AMD-H0534 Serial No. 10/618,191 Page 9

**Amendments to the Drawings:**

FIGURE × 5

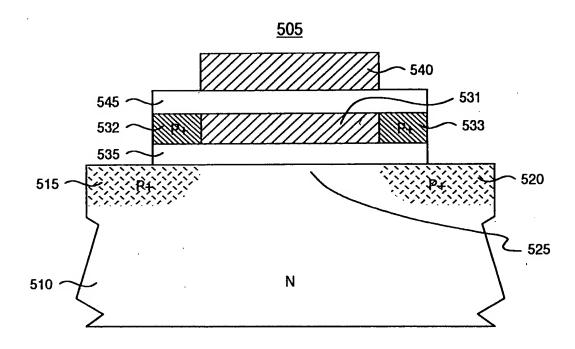
drawings has discovered that sheet 4 includes a drawing mislabeled as

Figure 4. Herein, sheet 4 has been changed so that sheet 4 includes a
